FOREST LAKES FILING NO. 7

COUNTY OF EL PASO, STATE OF COLORADO

CONSTRUCTION PLANS

MAY 2021

KEY MAP WITH TYPICAL STREET SECTIONS

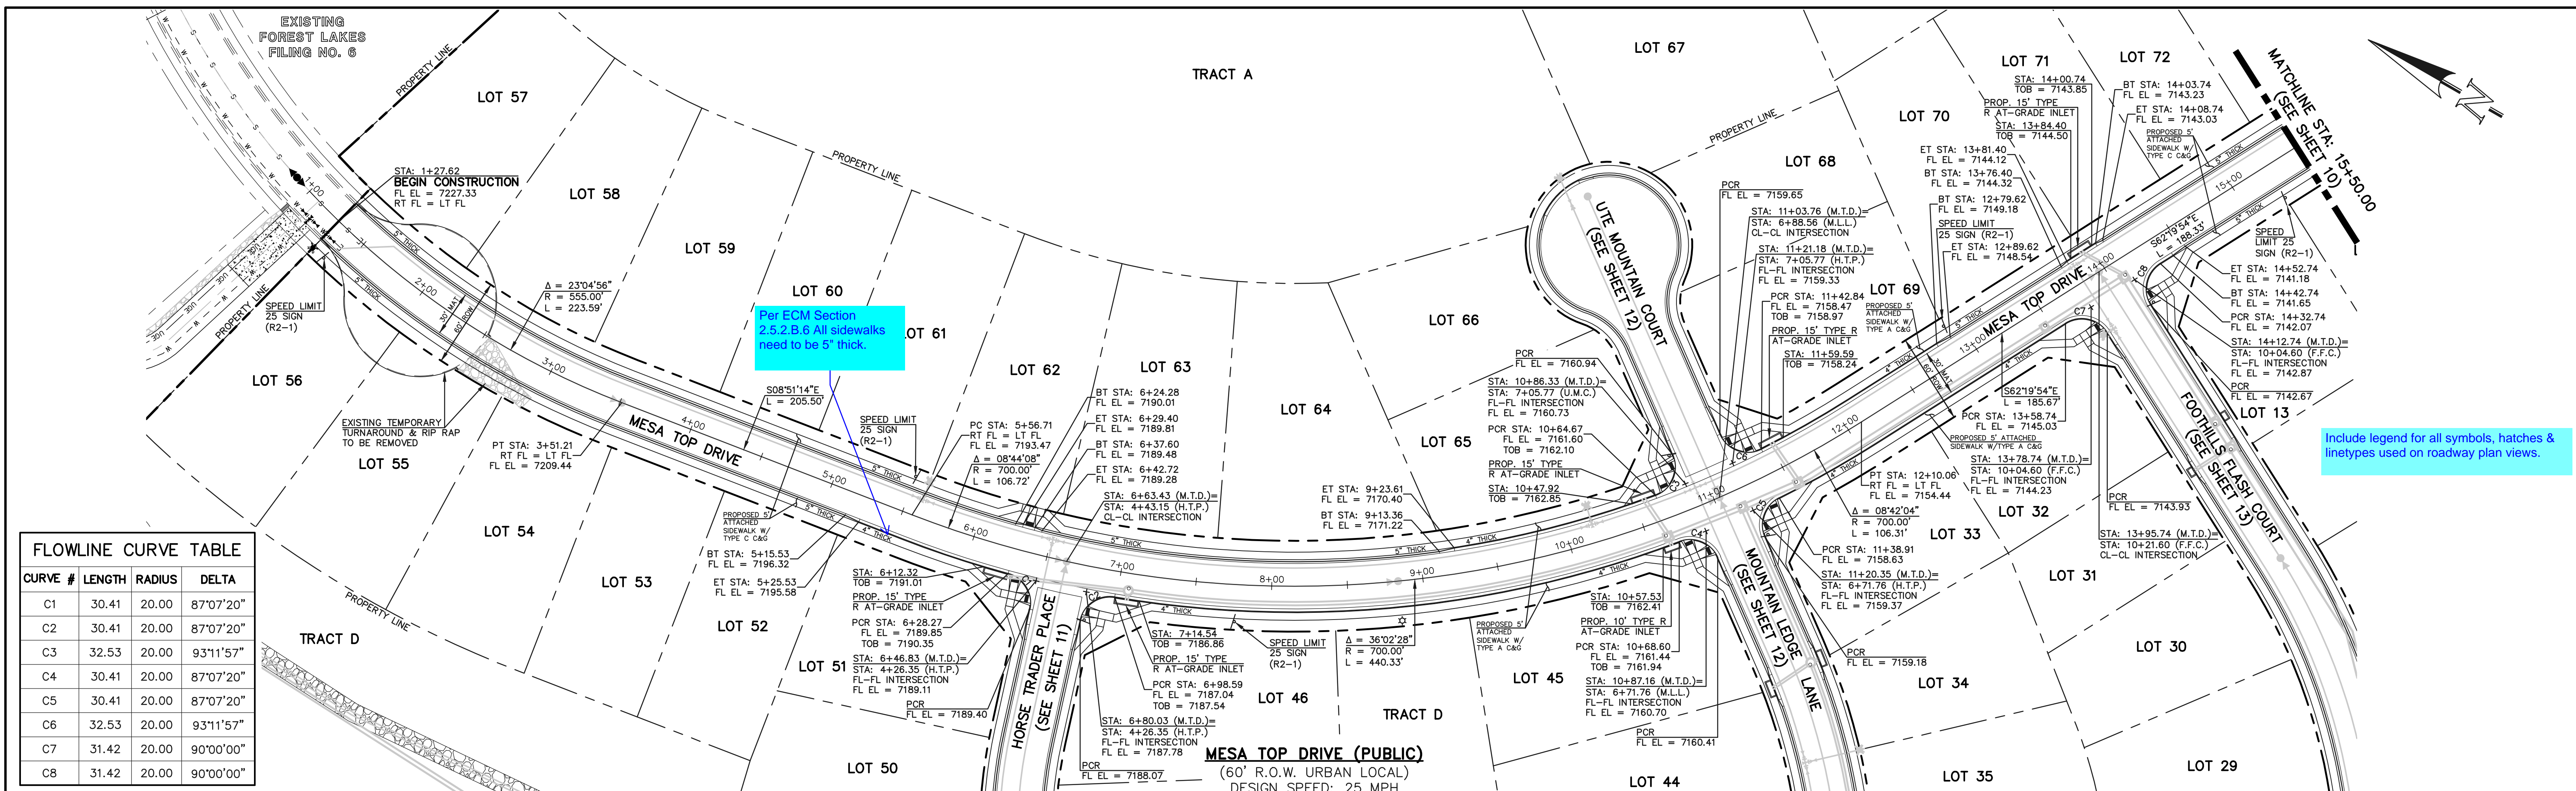
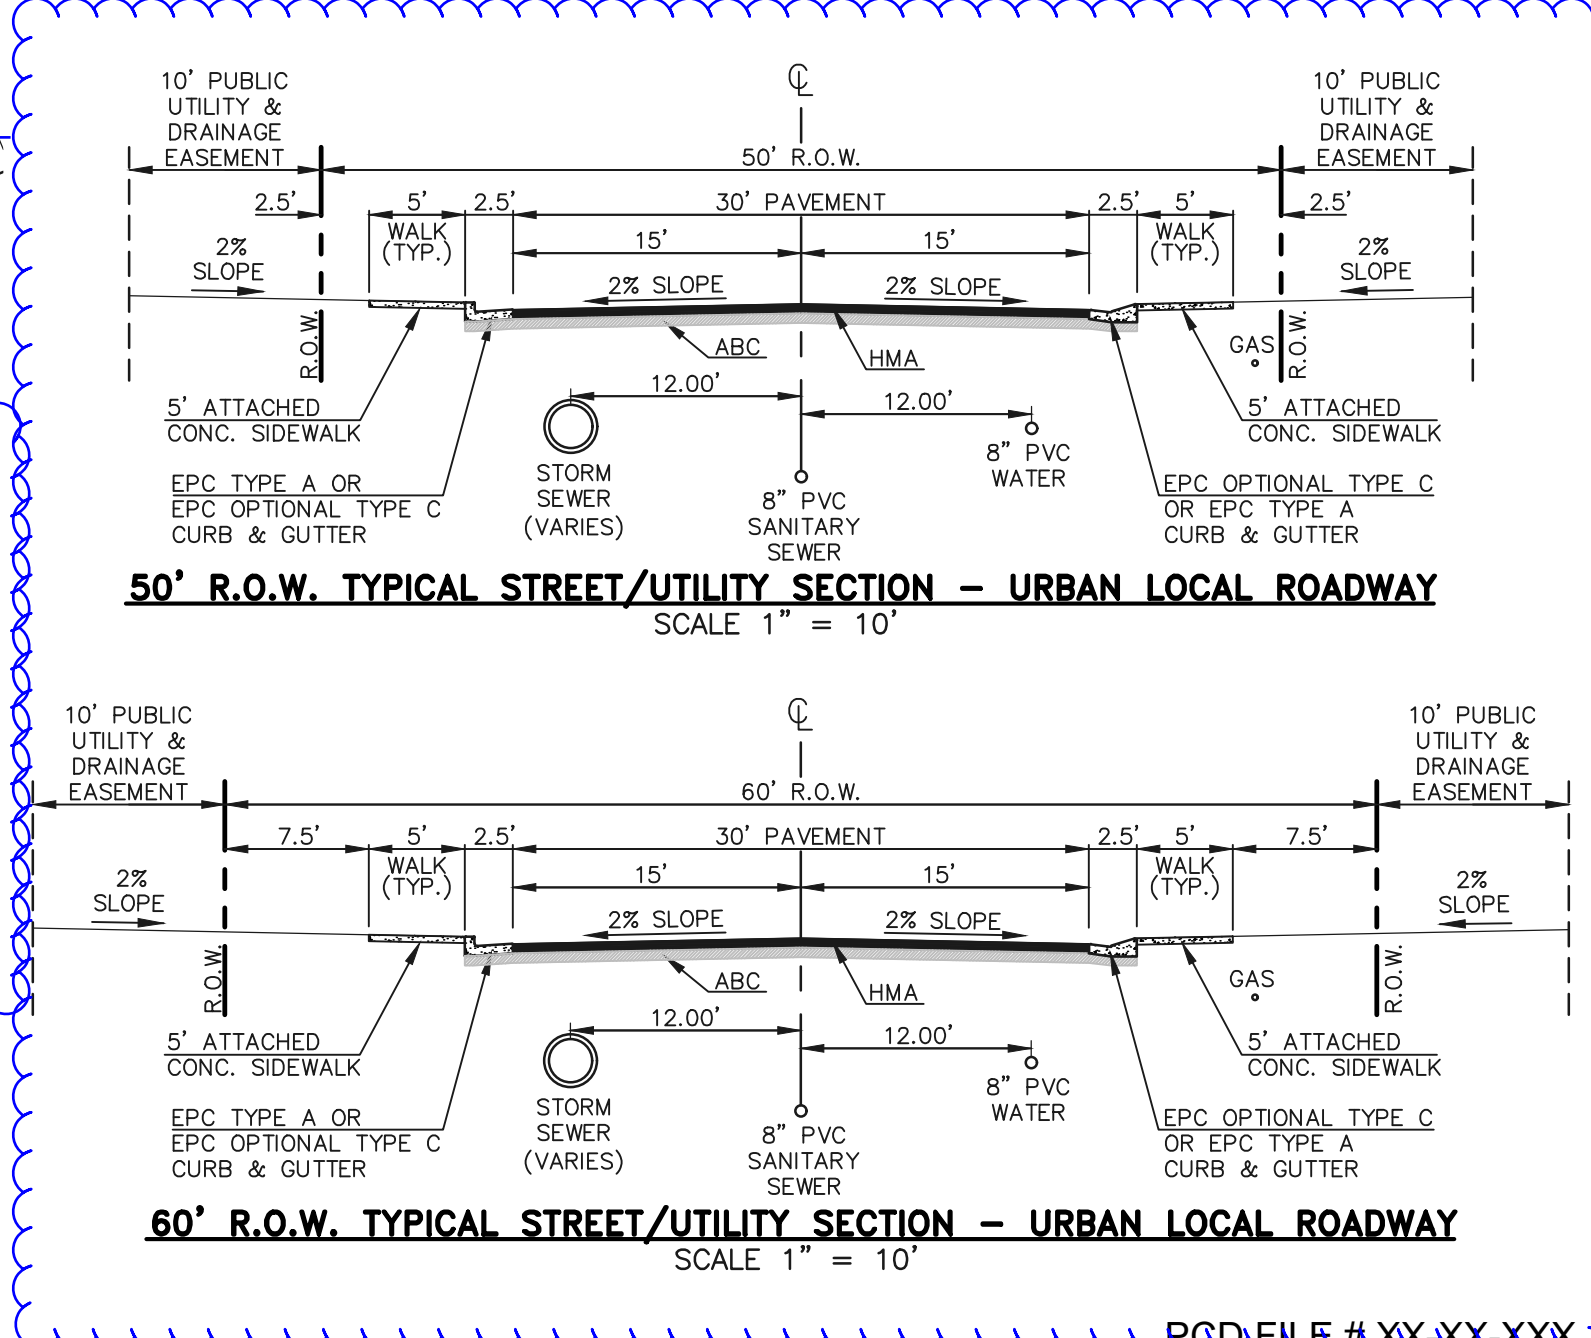
Utility placement does not match county cross sections - SD. 4-1 & SD. 4-2. Current placement has storm crossing under c&g in several locations. Please revise.

FOREST LAKES FILING NO. 7
CONSTRUCTION PLANS
PUBLIC STORM SEWER PLAN
'MAIN A'/'MAIN B'/'MAIN B LATERALS 1-2'
DESIGNED BY: MAL SCALE: (H) 1" = 50' DATE: 06/01/21
DRAWN BY: MES (V) 1" = 5' SHEET 16 OF 31
CHECKED BY: DATE: JOB NO. 1175.70

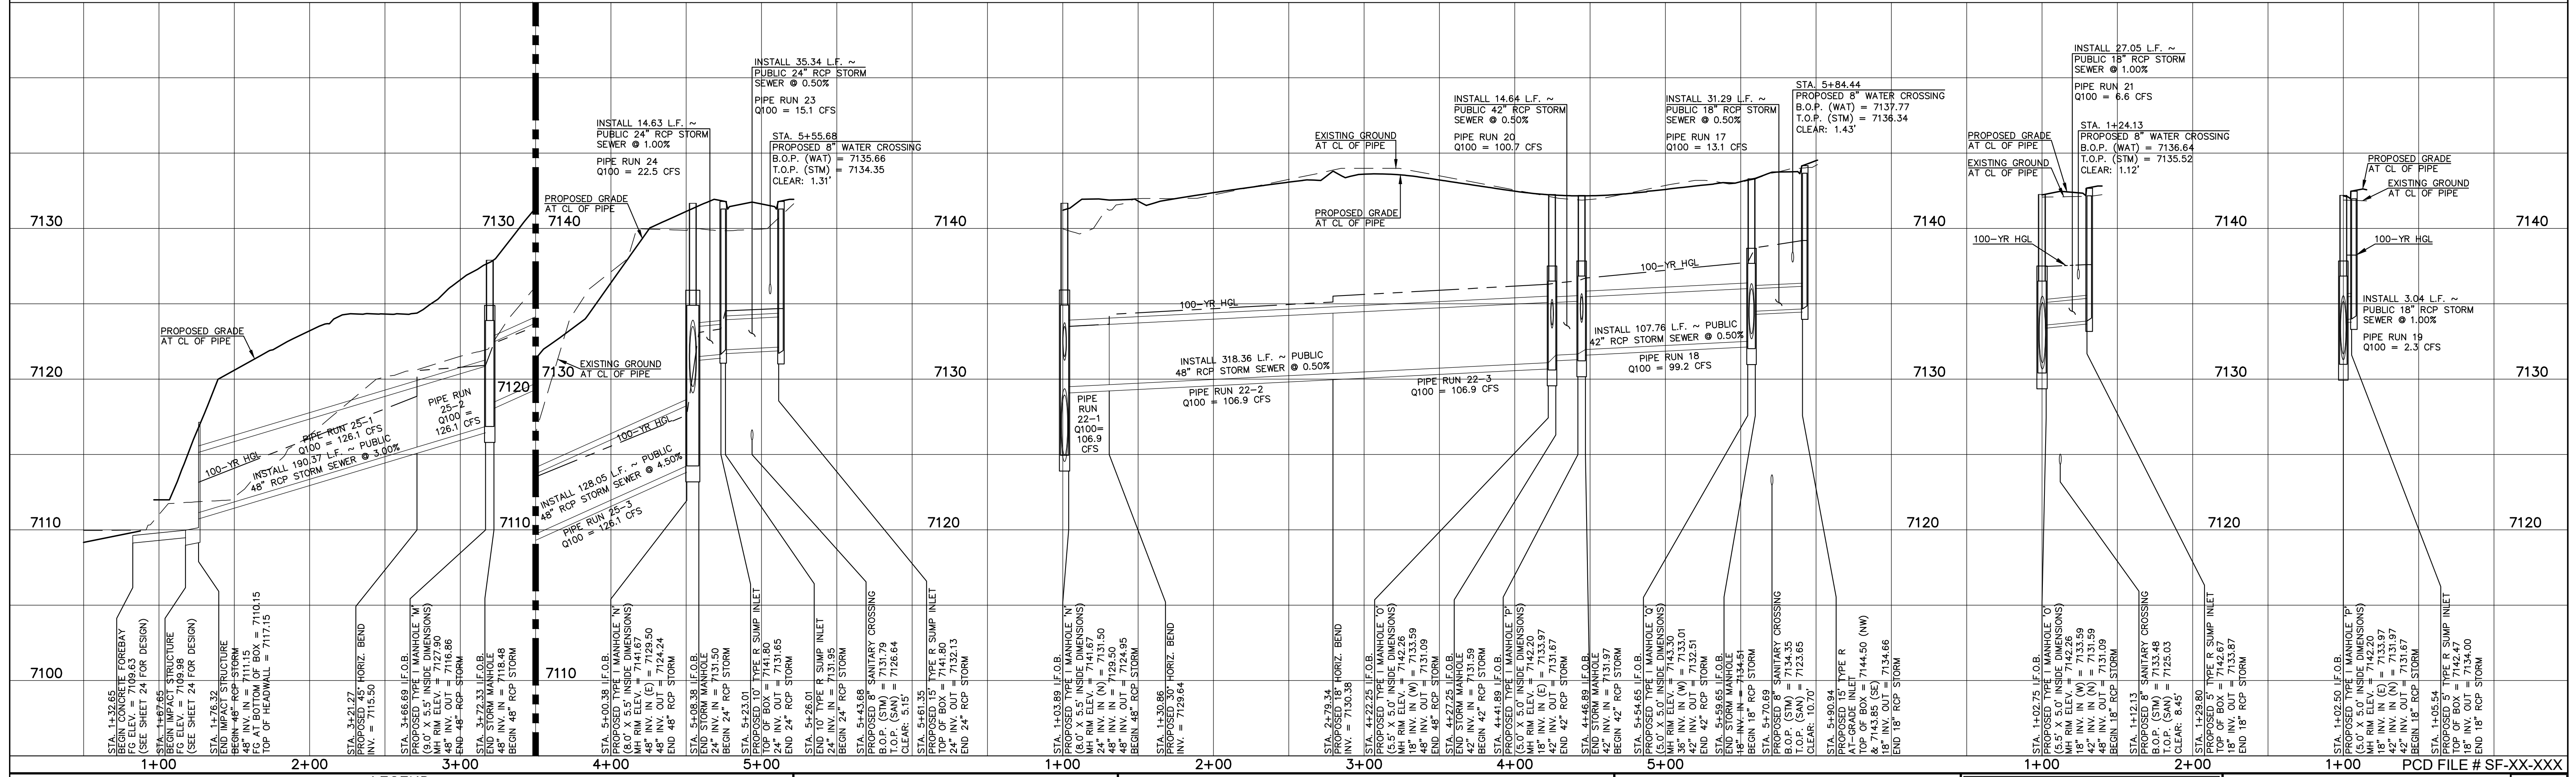
Due to possible changes to storm alignment, detail check was not done for this review.

OUTFALL 30" RCP BAFFLE STRUCTURE - PLAN VIEW
SCALE 1" = 5'

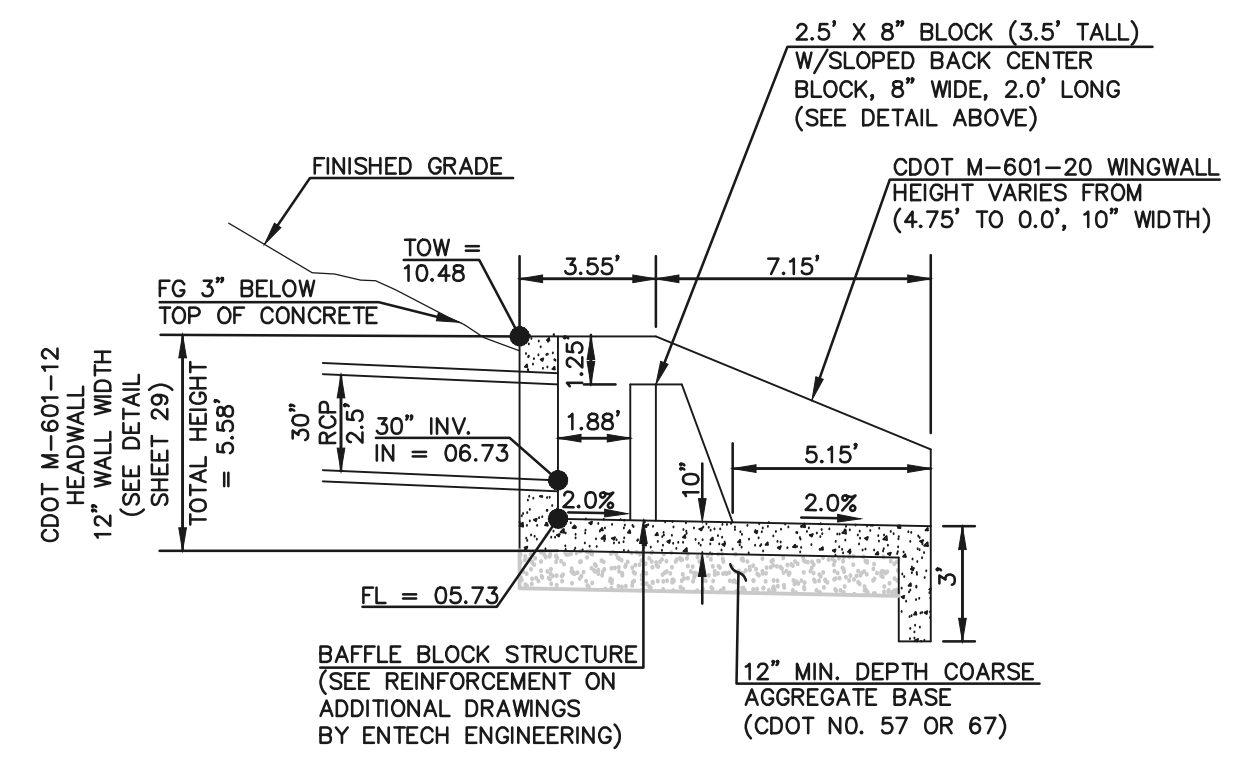
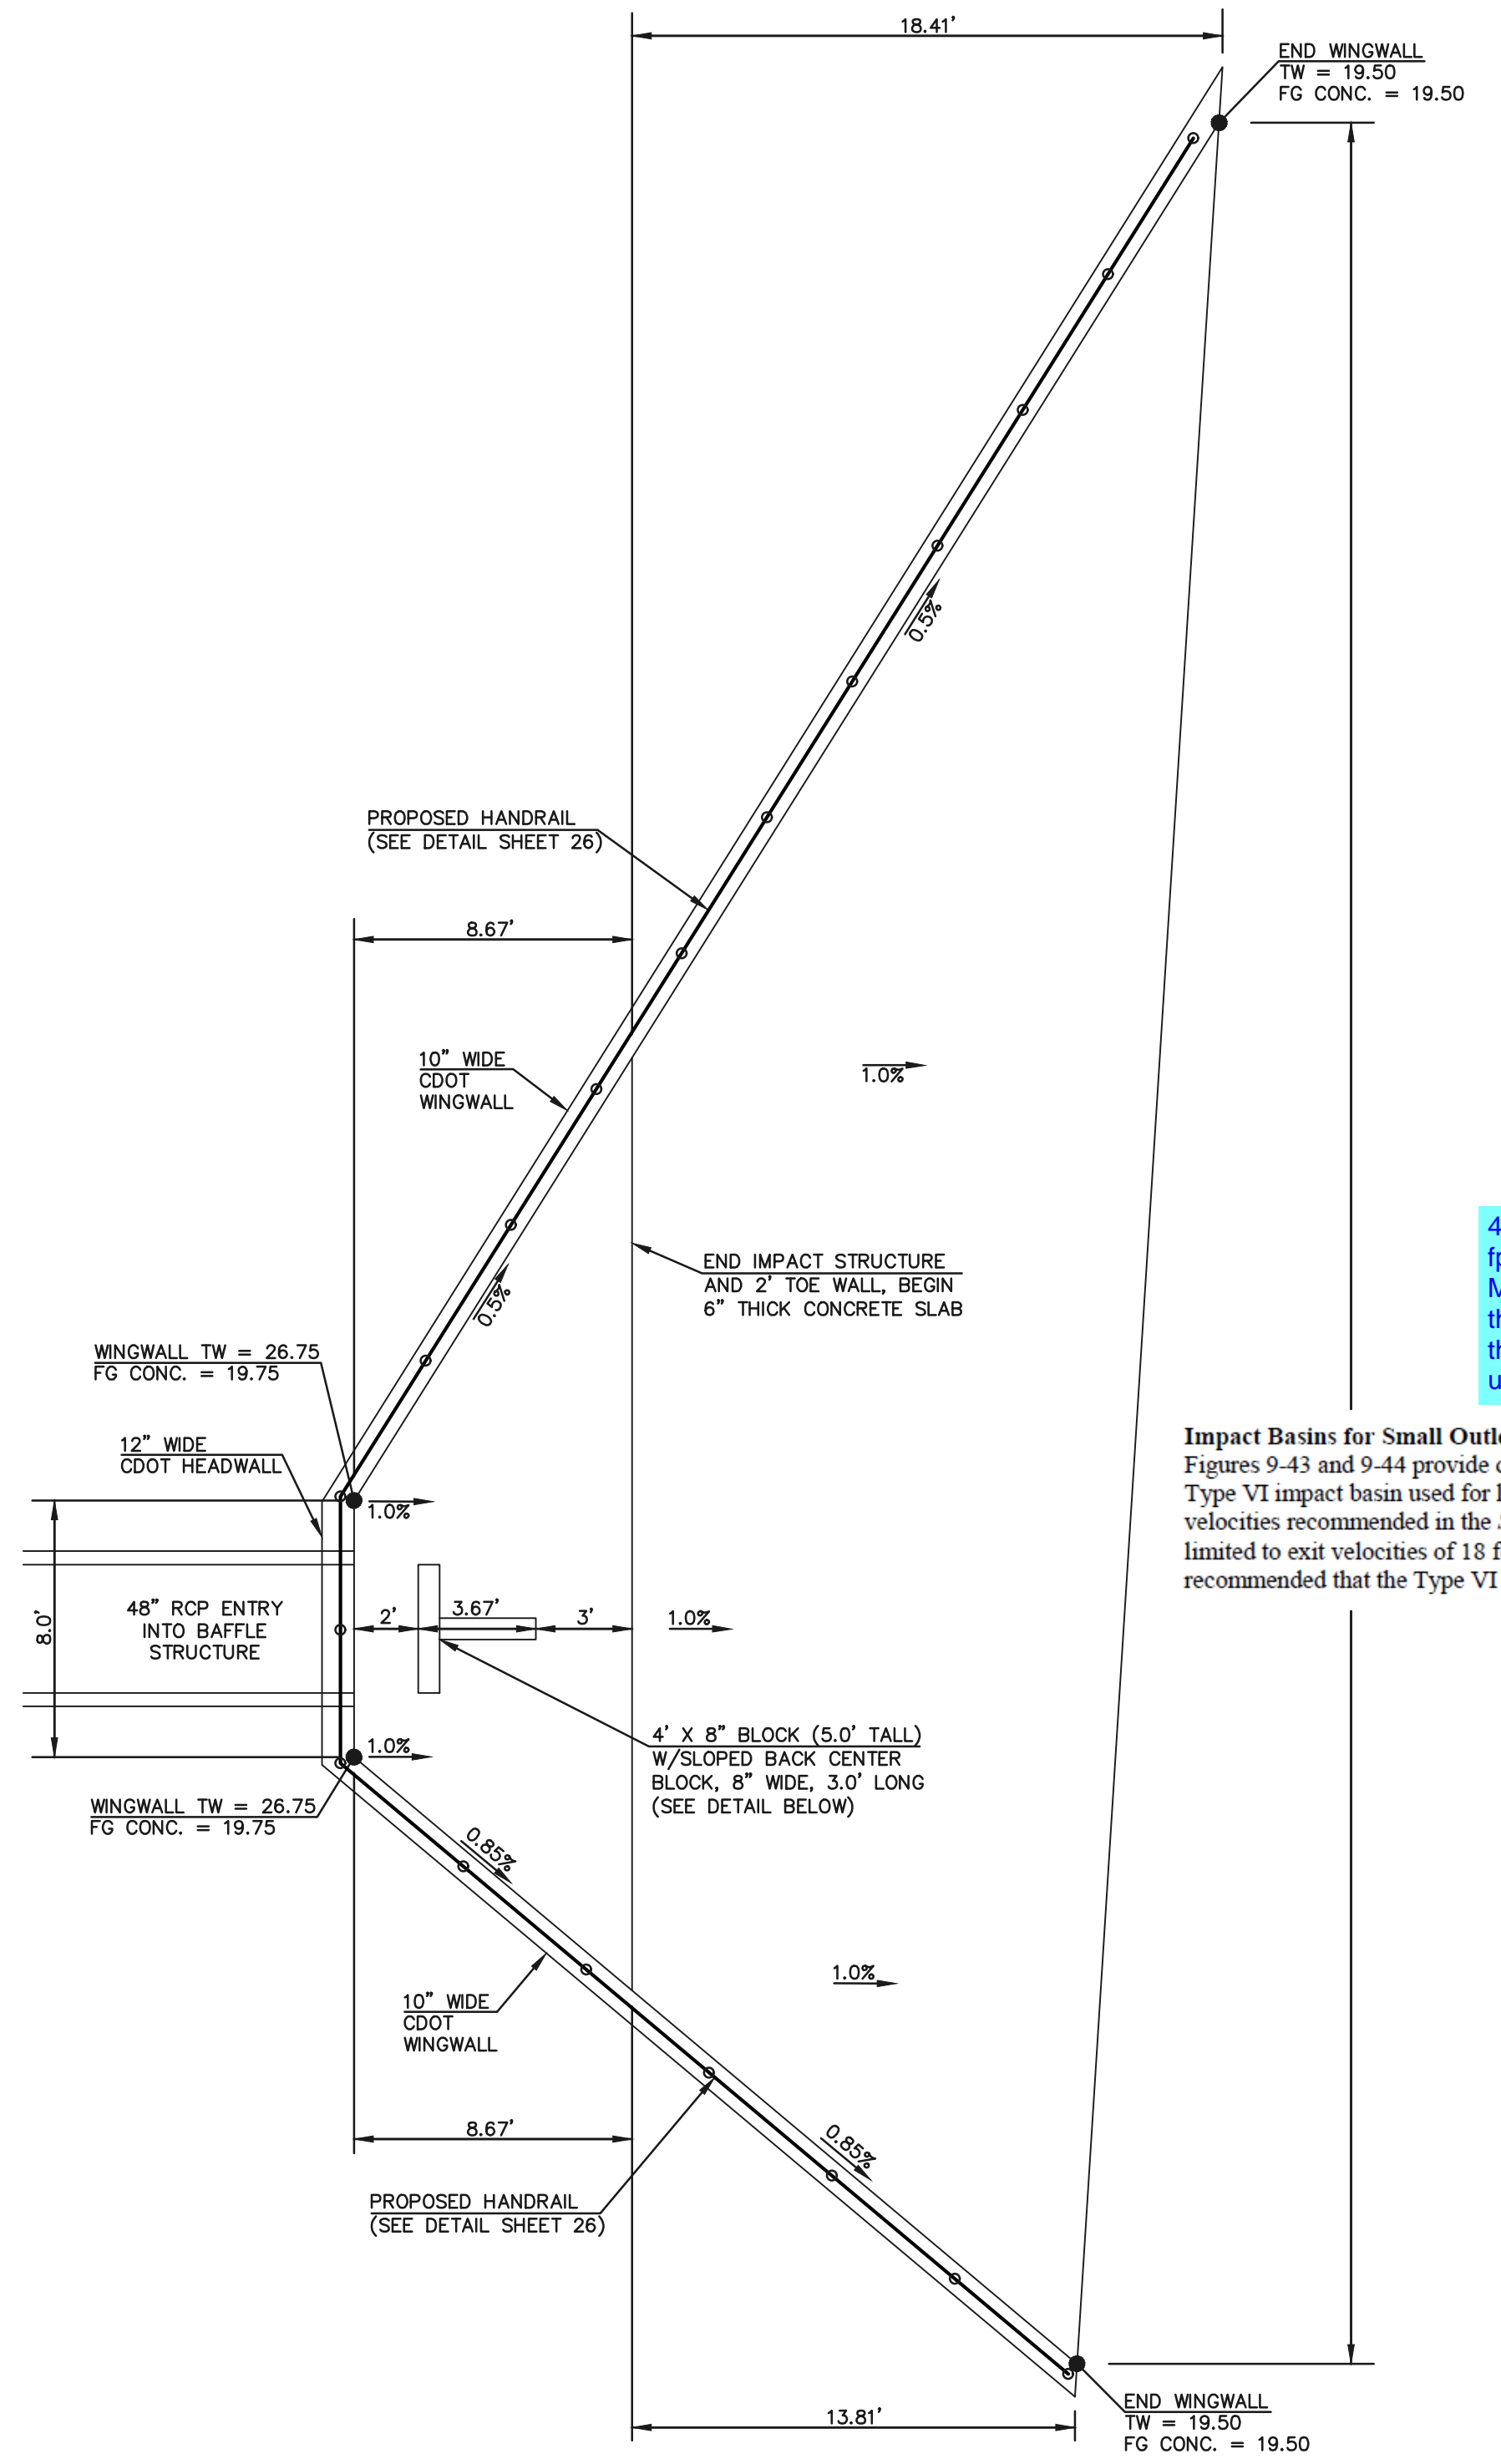
Is this detail for Pond A?
